APPENDIX N

N2
RESPONSE TO LA-CITY LEA COMMENTS
SUNSHINE CANYON LANDFILL CITY-COUNTY JTD
FEBRUARY 27, 2008

RE: RESPONSE TO LA-CITY LEA COMMENTS
SUNSHINE CANYON LANDFILL CITY-COUNTY JTD

RE: **RESPONSE TO LA-RWQCB COMMENTS**
SUNSHINE CANYON LANDFILL CITY-COUNTY JTD

FIGURE 7-E

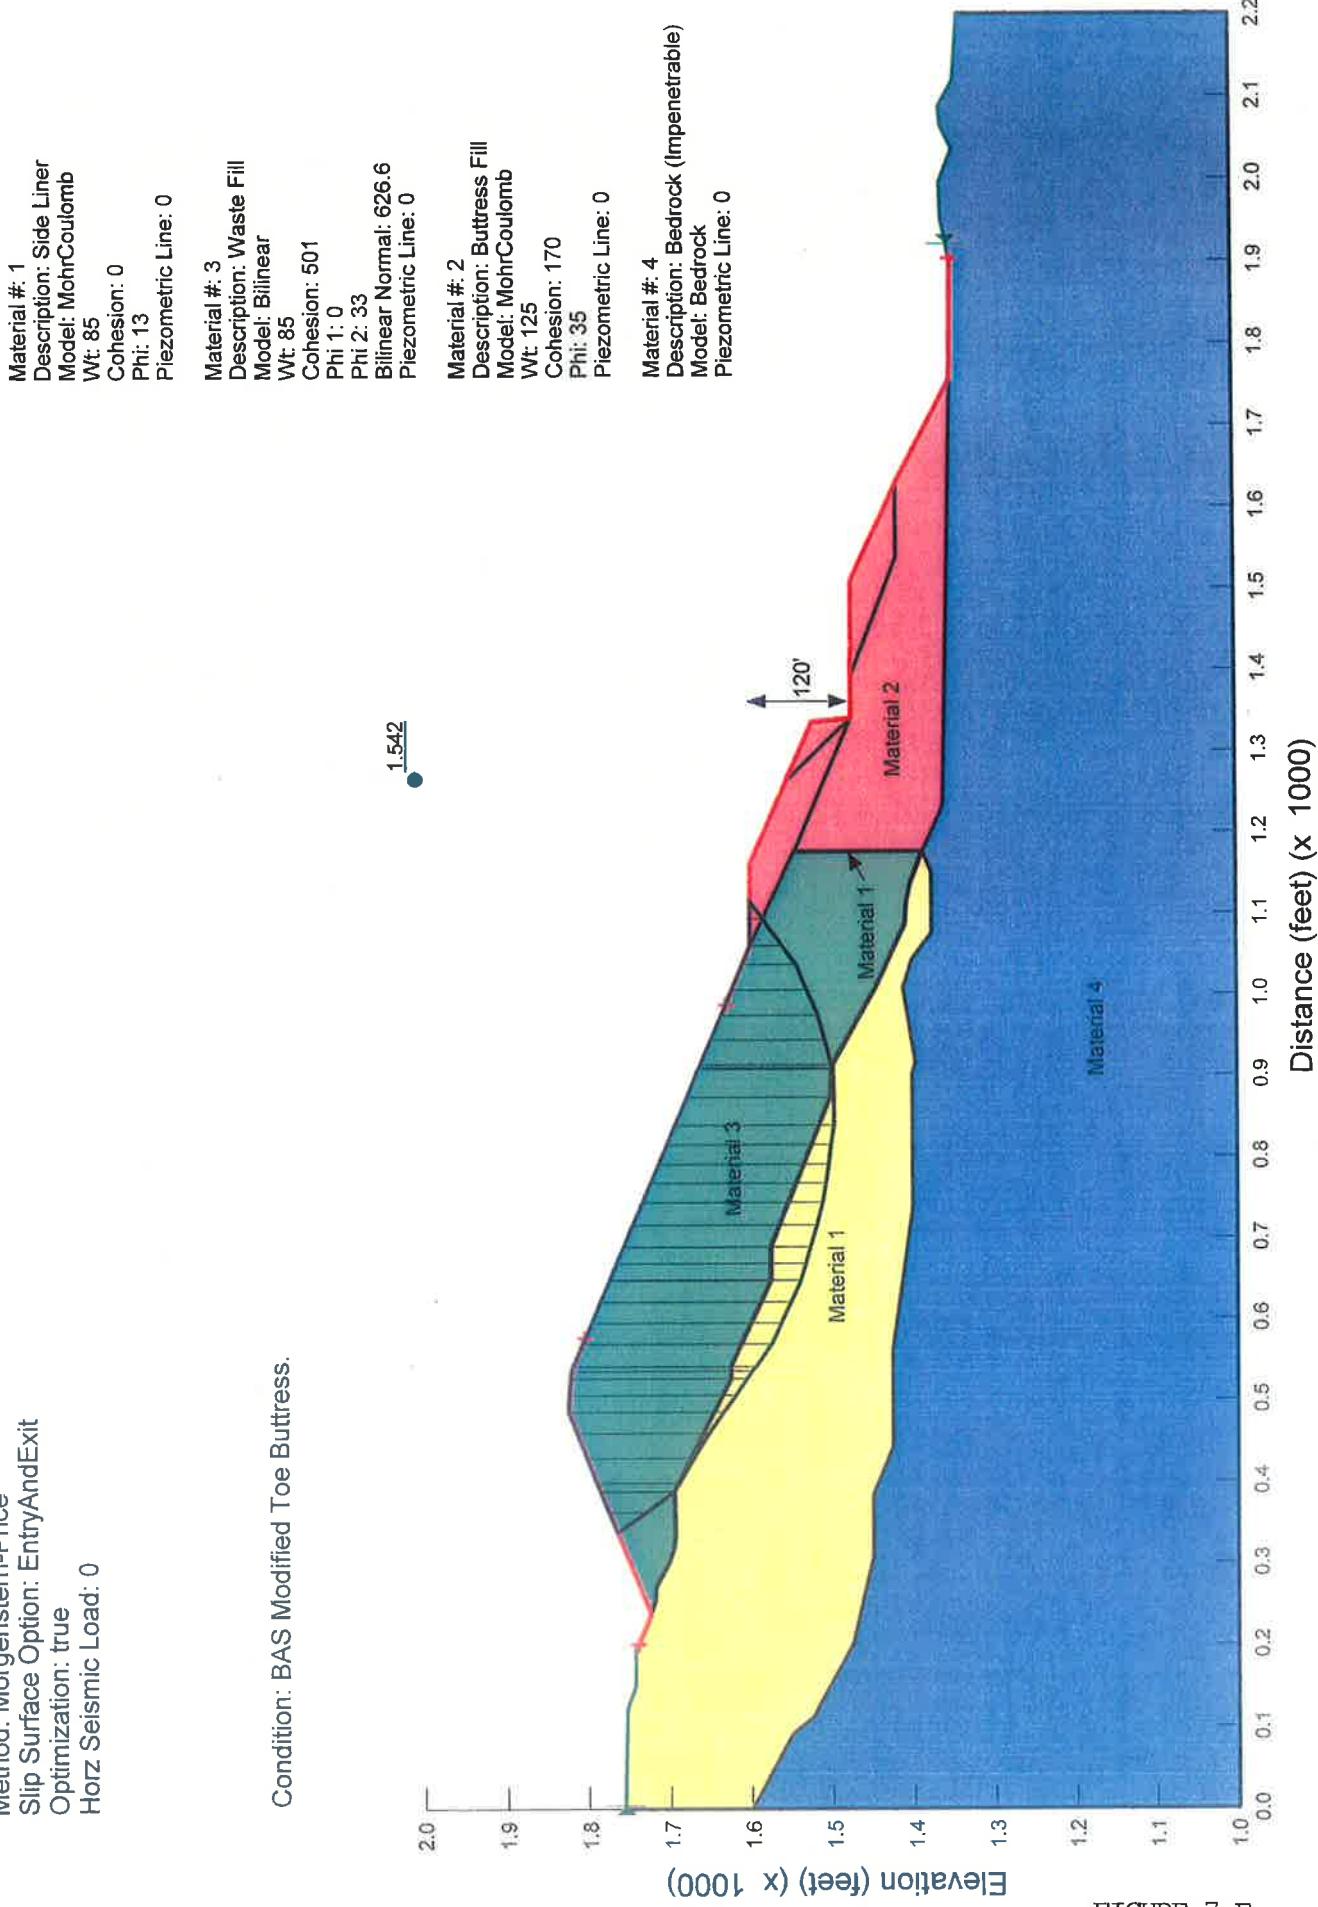
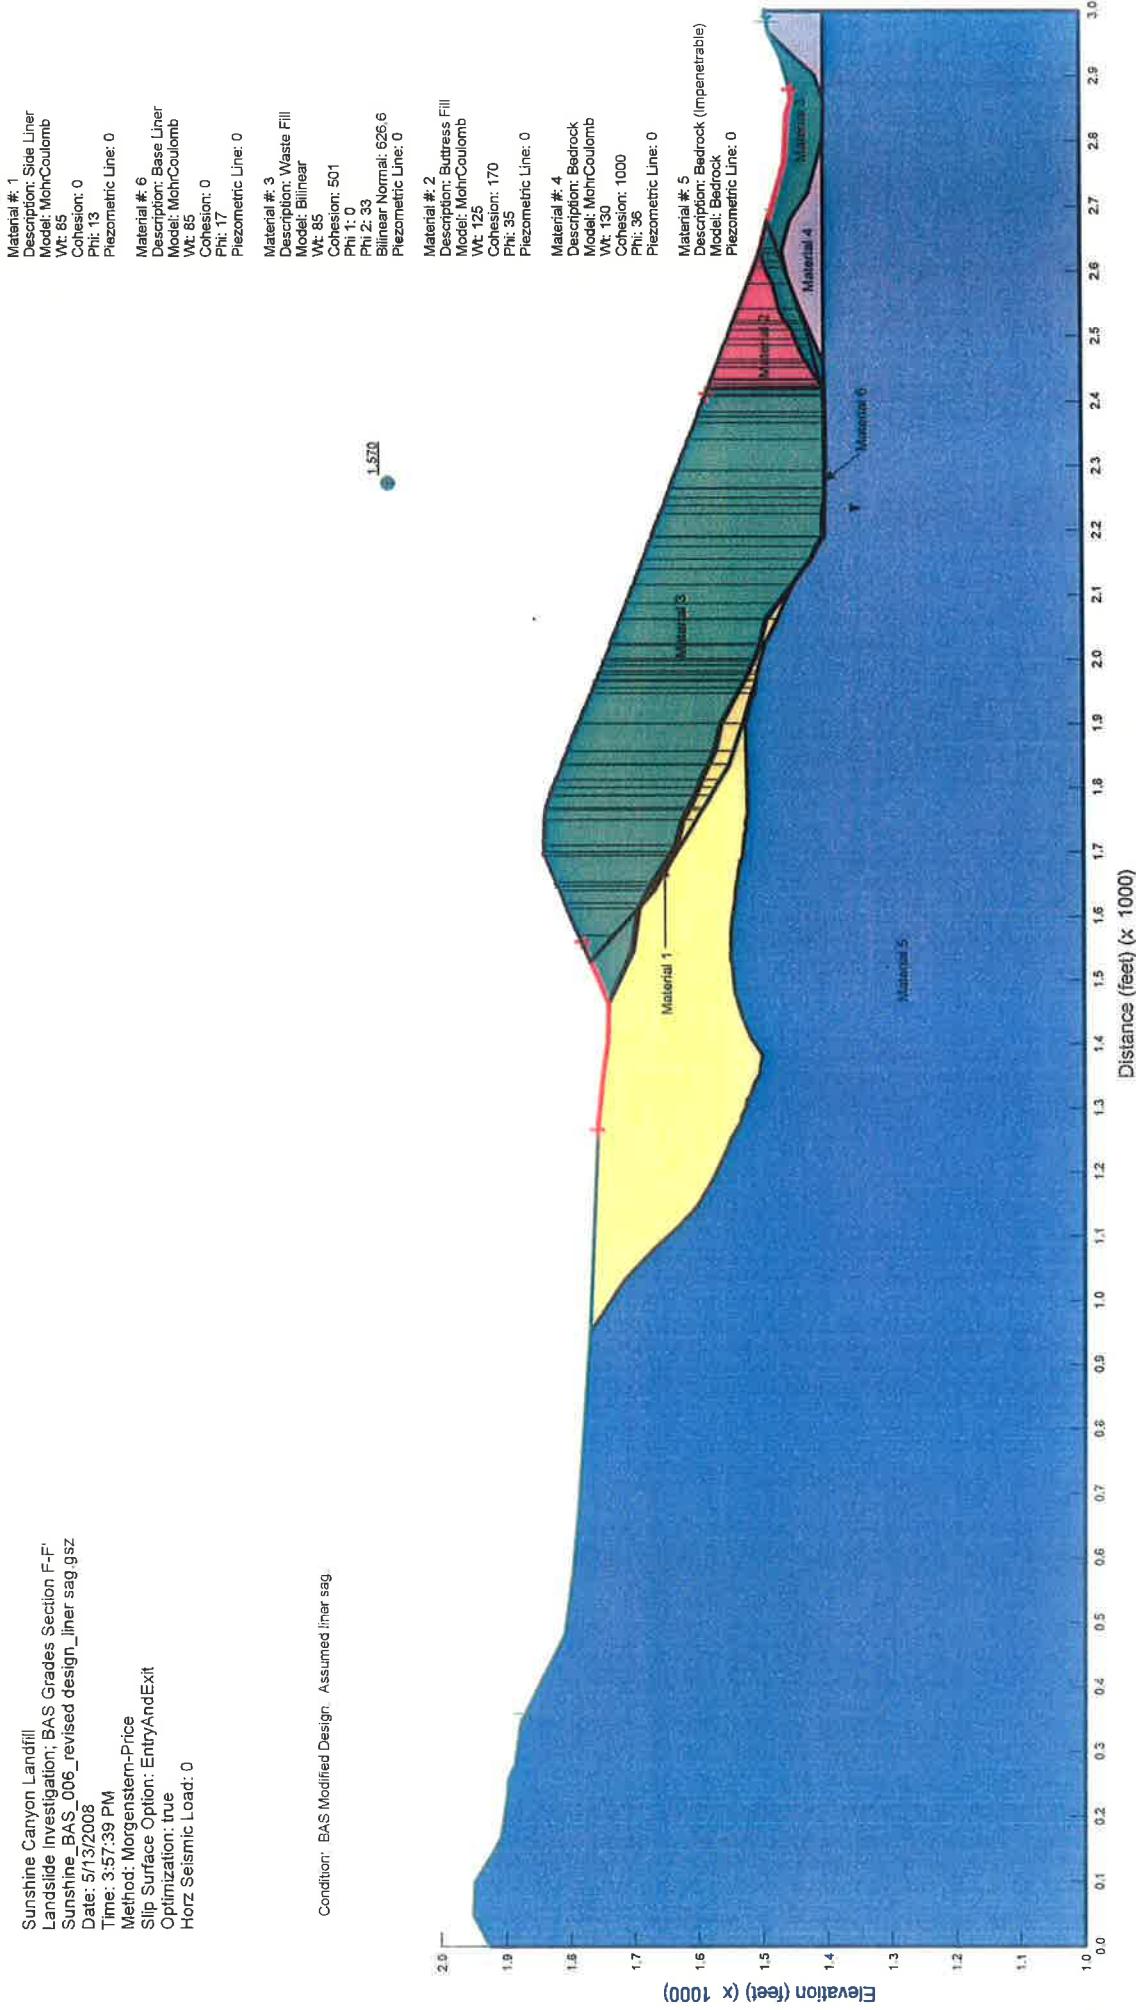
COMMENT 2 – STABILITY ANALYSES: *Appendix N of the JTD includes slope stability analyses that were prepared in 2002 for a previous JTD. However, landfill designs in the new JTD are different from those assumed in the 2002 JTD. Specifically, the new JTD proposes a double composite liner system and a final cover system that includes a low permeability (clay) layer, while the 2002 JTD assumed a single composite liner system and a final cover system that included geosynthetic clay liners instead of a clay layer. We understand that BFI will submit stability analysis design plans for each phase of landfill development. However, stabilities of the overall landfill configuration and final refuse slope must be demonstrated in the JTD. In accordance with section 21750(f)(5) of 27 CCR, stability analyses in the JTD must be updated.*

The unacceptable factors of safety for the consolidated Old City-Side waste configuration along Sections E-E' and F-F' are largely the result of the relatively shallow outside liner slope that is incorporated in the current design. Since this geometry creates a low strength critical exit geometry, it is recommended that the inside face of the toe berm be steepened and moved inboard prior to placement of a liner in order to force any potential failure to break out through the waste prism. Since incorporation of a steep, lined, inside berm face produces an adequate factor of safety for failure over the toe berm, the potential for a different critical failure to propagate through the toe berm was also evaluated. In order to effectively mitigate both potential critical surfaces, it is necessary to steepen the inside face of the toe berm, to widen the access road and to steepen the outside face of the toe berm. The results of these recommended two design changes are reflected in Figures 7-E and 7-F.
